**TOWN OF NEWBURGH
PLANNING BOARD
TECHNICAL REVIEW COMMENTS**

PROJECT NAME: VERIZON WIRELESS
PROJECT NO.: 22-18
PROJECT LOCATION: PRESSLER ROAD
SECTION 4, BLOCK 2, LOT 43
REVIEW DATE: 30 SEPTEMBER 2022
MEETING DATE: 6 OCTOBER 2022
PROJECT REPRESENTATIVE: YOUNG/SOMER, LLC- SCOTT OLSEN ESQ.

Re: Verizon Wireless of the East LP d/b/a Verizon Wireless
Application for Site Plan and Special Use Permit
Fostertown Road – New Tower Construction
Review Memo #1 (Inventory and Completeness)

Tectonic Viewshed Map with Proposed Balloon Test Viewpoints – Received September 13, 2022

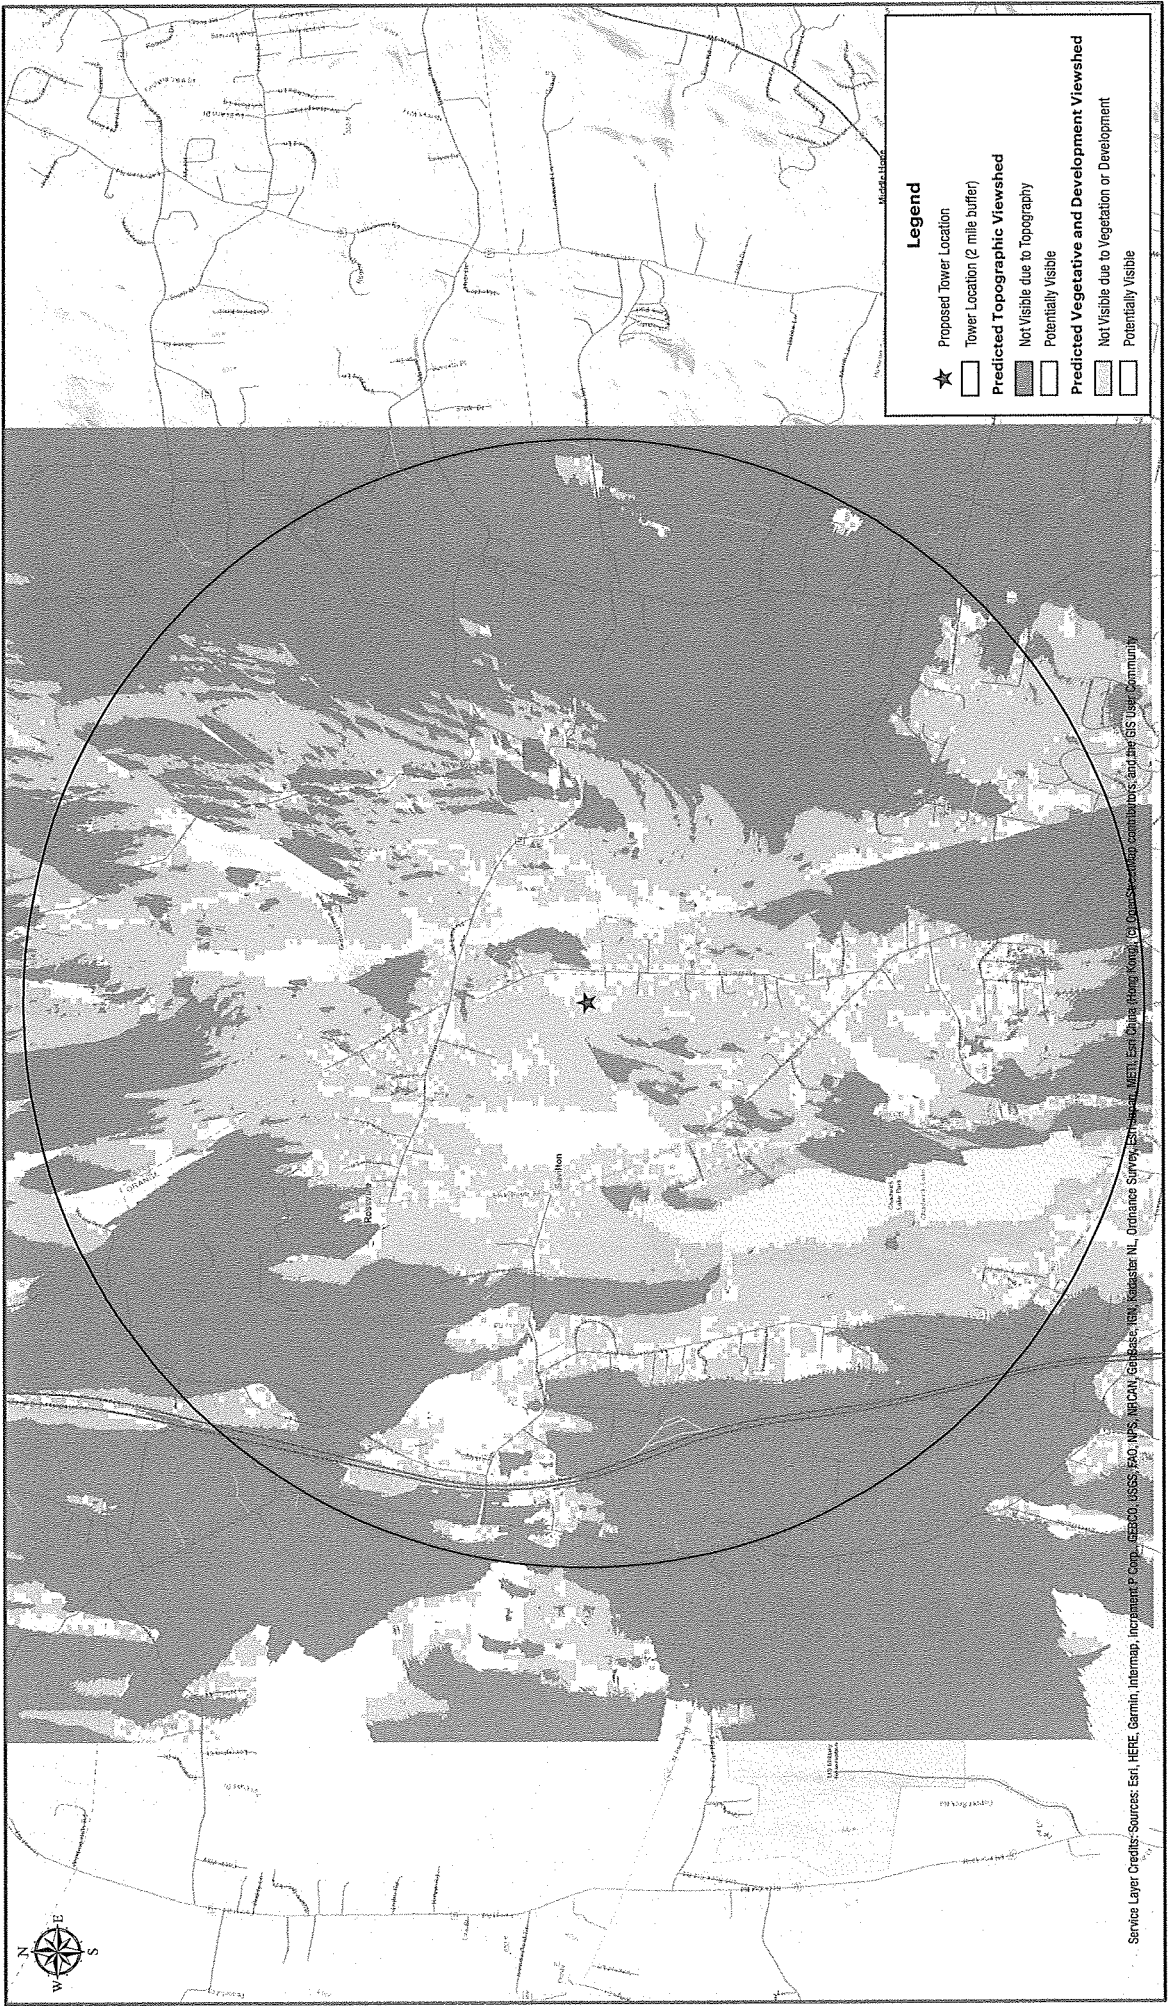
The applicant has provided preliminary viewshed maps that depict potential visibility based on “terrain only” and terrain in conjunction with vegetation and land cover as part of the application materials. The maps are computer generated predictions and provide an estimate of real-world conditions. One copy of the viewshed maps (received September 12, 2022) includes 21 viewpoints proposed to be evaluated during the future balloon test. The rationale for each point is not clear based on the information provided; however, final viewpoints may be discussed with the Planning Board and decided upon prior to the field mobilization. Additional viewpoints may be added in the field based on observations (as is typical). A copy of the applicant’s viewshed map with proposed photo locations is provided in **Attachment B**.

Based on the viewshed map, it appears that visibility of the proposed tower likely exists over a substantial portion of the area covered by a 2-mile radius including Chadwick Lake Park, Mountain View Avenue, Fostertown Rd/State Route 32, Pressler Road (and some local streets off of Pressler Road in Newburgh and Plattekill), and along East Road in southern Ulster County. HDR agrees that the 21 proposed points appear to be reasonable and appropriate to serve as a guide to assess potential visibility during the balloon test. As noted earlier, it is common that additional viewpoints could be added during the balloon test when visibility can be better assessed.

- **HDR requests that prior to conducting the balloon test, the applicant provide a tabular list of the 21 proposed viewpoints that can be correlated with their location on the provided viewshed map (e.g., numbering system). The list should provide the common name and address or other obvious means of identifying a given location in the field (e.g., cross street), distance and direction to the tower, and the rationale for evaluation (e.g., publicly accessible lands, parks, listed or eligible historic sites, etc.).**
- **HDR requests that the viewshed map(s) have the following added to better clarify and identify the potential and proposed viewpoint locations:**
 - Zoning districts
 - Municipal and county boundaries
 - Historic/cultural resources (listed/eligible)
 - Schools
 - Parks
 - Public areas

Separate maps (one for bare earth/topography only and one for land cover added, each with their own legends and color patterns) should be submitted, with the above information added to both maps.
